Visual Dam Inspection and
Geotechnical Exploration Report
Review

Norman Road Dam

Clarkston Lake

CLIFS-18-GA-02795-01

- 9.) Downstream Slope (Looking North) –
Instability;
Poor Condition.

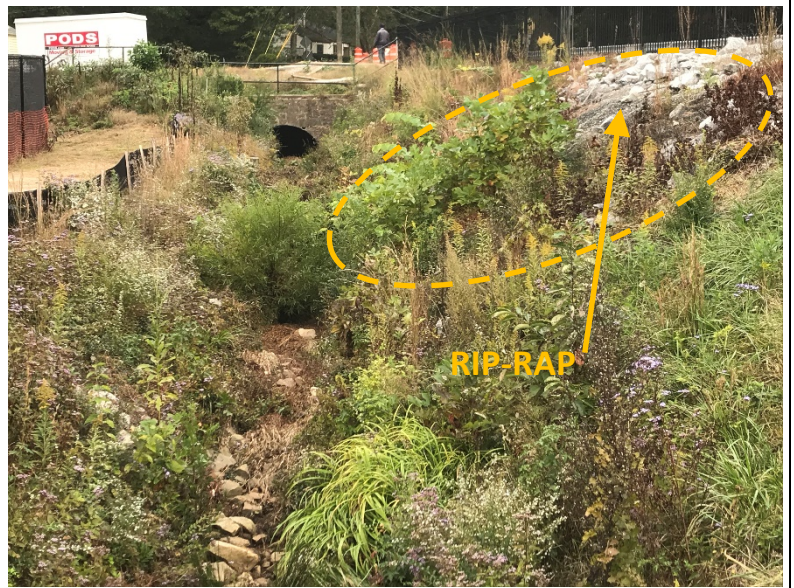
The east slope (left slope) shows an area that has been stabilized with rip-rap and grouted pavers near the crest.

10.) Downstream Slope (Looking West) – Vegetation & Instability; Poor Condition.

The downstream slope has overgrown grassy and shrubby vegetation preventing proper inspection for animal burrows, wet/seepage areas, instability and erosion. The slope varies from 0.5h:1v (west end) to 2h:1v.

The west slope (right slope) shows an area that has been stabilized with grouted rip-rap from the crest to near the toe of the slope.

- 15.) Principal Spillway – Discharge Pipe-Arch 82" – 48" CMP (Looking North-Upstream)
Fair Condition.

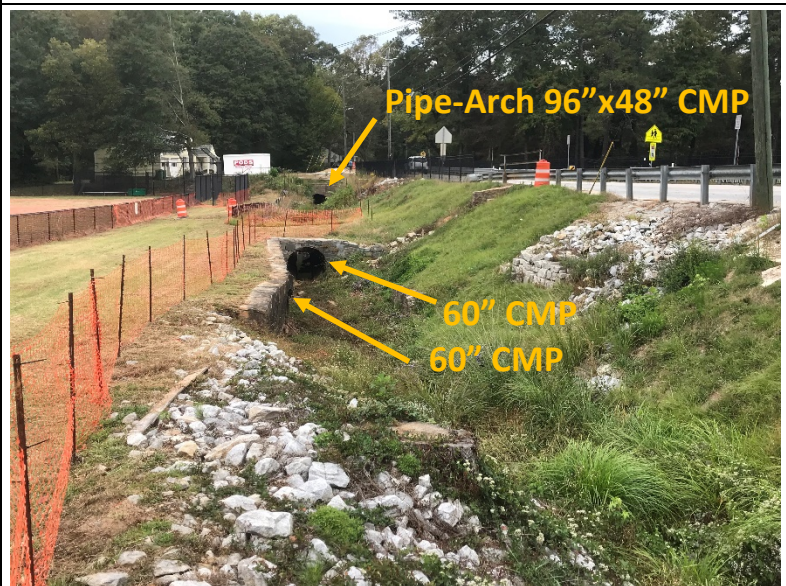
Looking inside the 82" – 48" Pipe-Arch CMP. Some sediment and rock cobbles/boulders on the bottom of the pipe-arch. No evidence of pipe deformation or corrosion of concern noted.
